S.S. PAPADOPULOS & ASSOCIATES, INC.
ENVIRONMENTAL & WATER-RESOURCE CONSULTANTS

Subject: Strada Aggregates Inc. Melancthon Pit/Quarry groundwater modelling review

On behalf of Melancthon Township, we have reviewed the Strada Pit/Quarry Level 1 and 2 Hydrogeological Assessment (Tatham Engineering and Earthfx Inc., 2025).

Figure 2. Stations with precipitation data
Source: Adapted from Appendix D, Figure 3.21

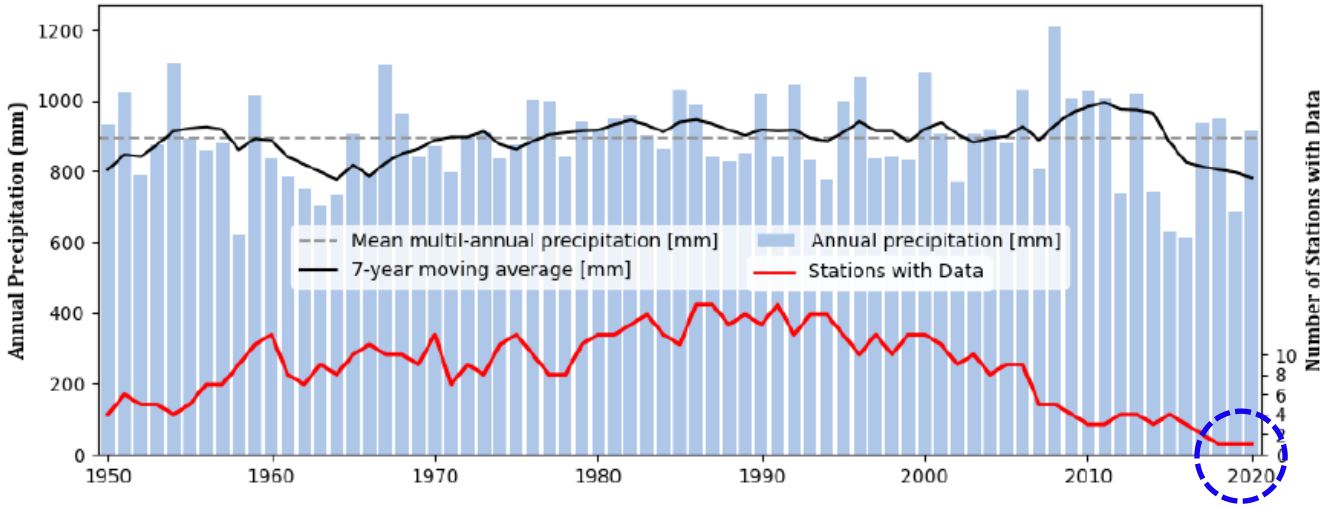
2. As highlighted in Figure 2, since 2018 there has been only one station with precipitation data. The location of this station with respect to the footprint of the proposed quarry is not indicated. There is no indication that the data from this station are complete, and whether the data are representative of conditions around the quarry. There is no indication of the uncertainty in the analyses created by the reliance on the data from a single climate station.

Figure 3. Available well coverage

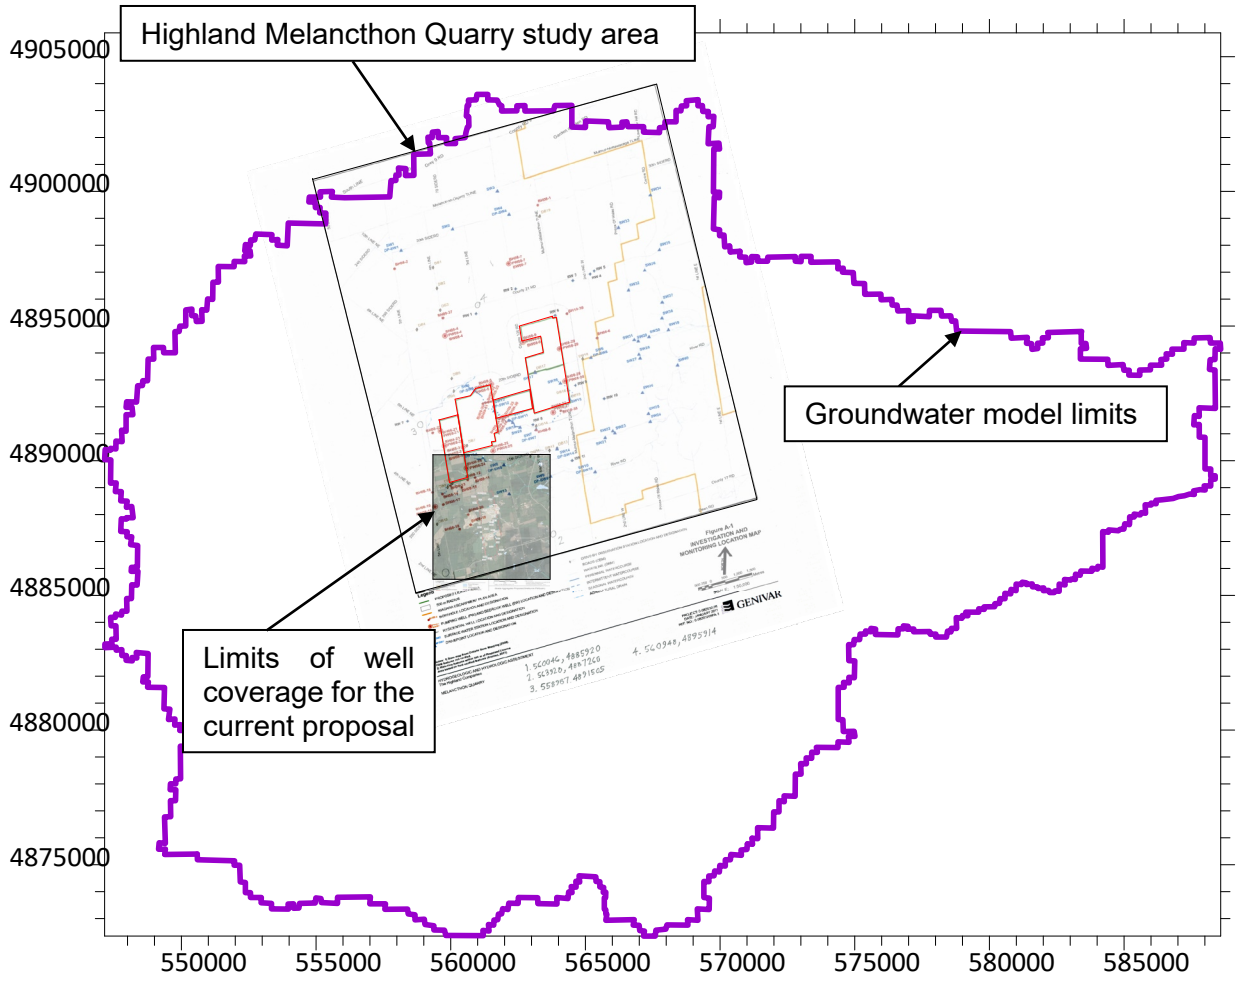
4. The site monitoring network is limited to the area immediately surrounding the proposed quarry. This network is not sufficient to support the groundwater model. As shown in Figure 3, the area covered by the Strada monitoring network is a small portion of the model area. Data from the investigations for the Highland Melancthon Quarry are available from beyond the Strada network. Data from Highland Quarry should be considered in the analyses (GENIVAR, 2011). These data will at least fill in some of the gaps in the area north of the proposed quarry. [Clearer versions of the two figures are included in an appendix to this letter.]

Figure 6. Locations of private wells near the proposed quarry
Source: Adapted from Figure A.6

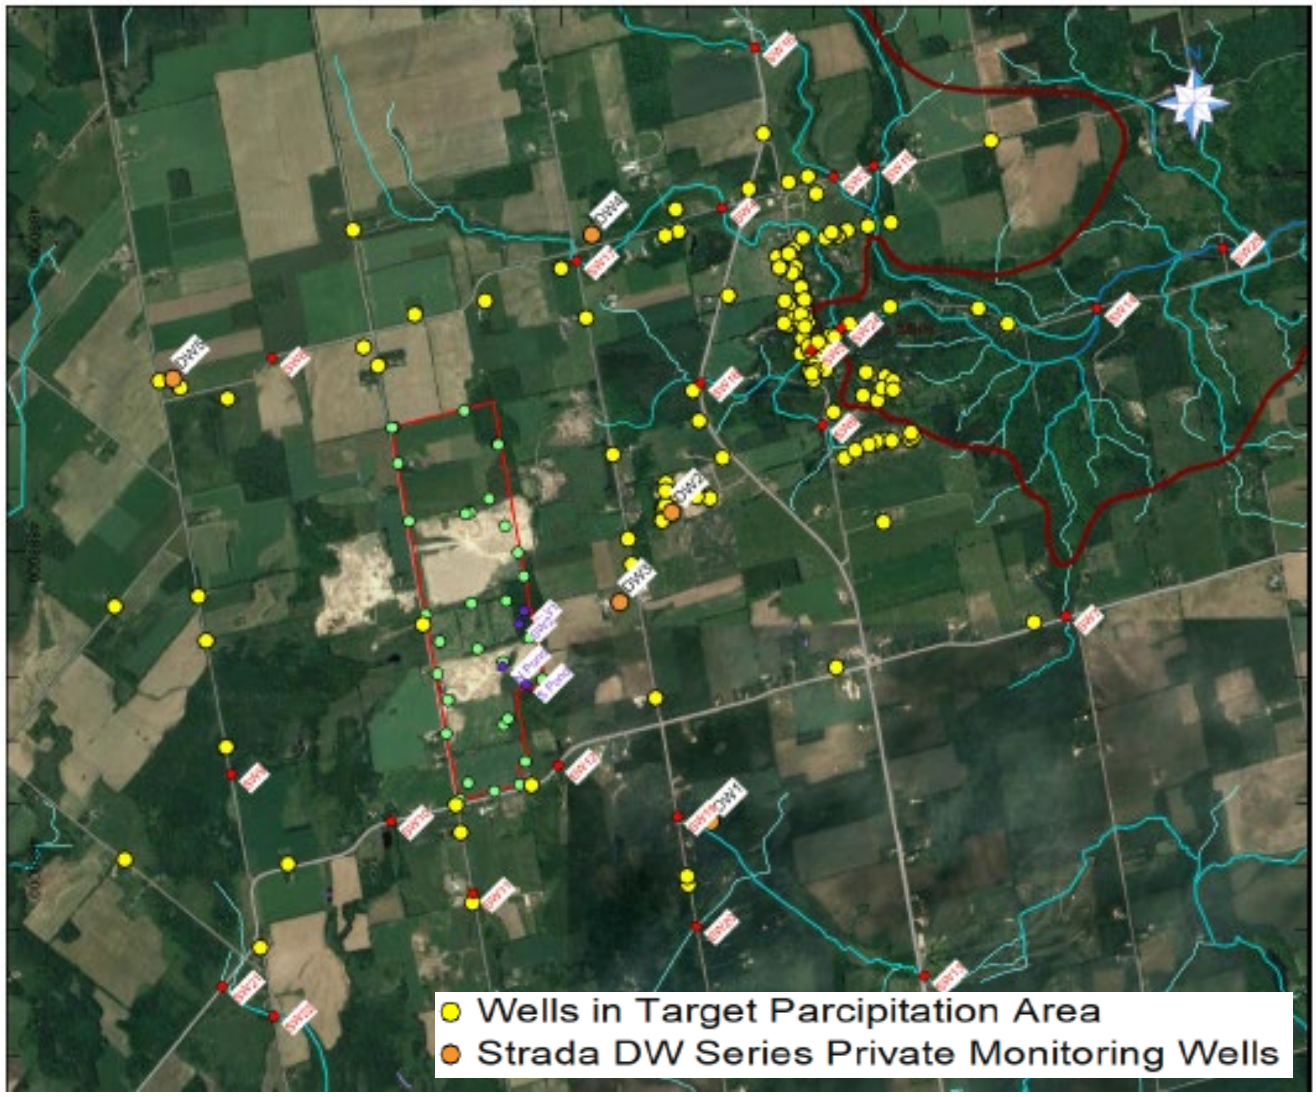
A map showing private wells in the vicinity of the proposed quarry is presented in Appendix A, Figure A.6. The yellow circles shown here in Figure 6 denote wells labelled as "Wells in Target Participation Area." The map suggests that there are several private wells that are closer to the proposed quarry. The impact assessment does not address potential impacts to these wells.

The orange circles in Figure 6 denote wells labelled as "Strada DW Series Private Monitoring Wells." Referring to Table A.1, there are five private wells in the long-term monitoring program, DW1 through DW5. Although the hydrographs for the wells are shown in Figures B.46 through B.50, the wells are apparently not included in the targets for the calibration of groundwater model. Simulated water levels at these wells during quarry development are not presented.

The consideration of potential impacts to private wells in the Level ½ report is incomplete. The report does not include a well interference protocol. The report does not include any site-specific data that confirm potential impacts can be alleviated by deepening existing wells. In this setting it is typical that the hydraulic conductivity of the bedrock and the quality of groundwater declines with depth. It is not a foregone conclusion that deepening wells will remedy impacts to all private wells.

Figure 7. Cross-section through Phase 4 of the proposed quarry
Source: Adapted from Appendix E, Figure 3.39

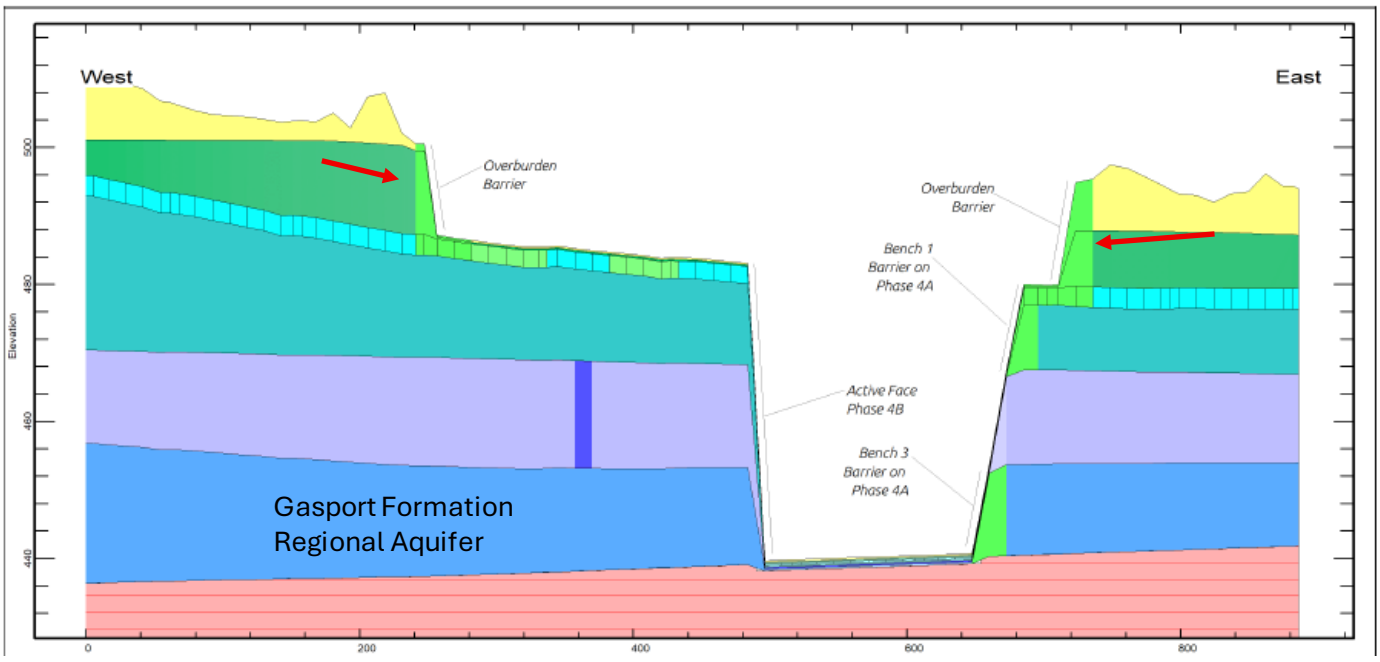
The planned phases of the proposed quarry are illustrated in Tatham and Earthfx (2025) Figures 3, 5, 7 and Appendix E Figures 3.5, 3.22 and 3.39. As shown in Figure 7, the final phase of the proposed development involves the complete removal of any protective strata above the regional aquifer, the Gasport Formation. There is no discussion in the impact assessment of the potentially important consequences of this with respect to regional water quality. In effect, there will be a direct pathway to the Gasport Formation for any sources of contamination within the capture area of the quarry.

Figure 8. Distance between the Strada site and the Shelburne municipal production wells
Source: Adapted from Appendix D, Figure 4.7 [page D-105]

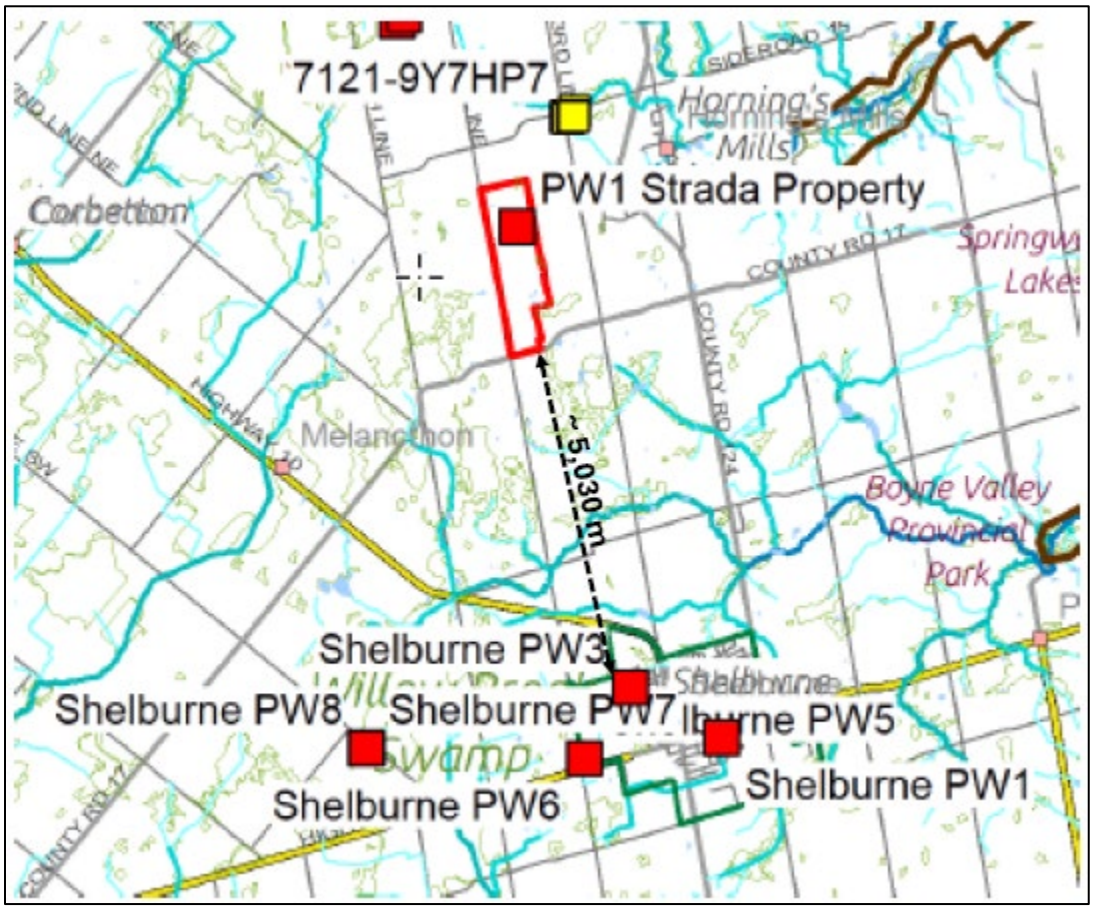
As shown in Figure 8, the proposed quarry is located about 5,000 m from the nearest Shelburne municipal production wells.

Referring to Appendix D Figure 4.15, the regional interpretation suggests that the groundwater level at the Shelburne wells is about 480 masl (this is consistent with the results shown in Figures 4.32 and 4.33). It is likely that this level corresponds to non-pumping conditions. As shown in Appendix C Figure 5.10, during the 2021 pumping test conducted at the PW7 and PW8, the water level in the Gasport Formation declined to about 456 masl. It is likely that the wellfield levels are lower when the wellfield is operated at its full capacity.
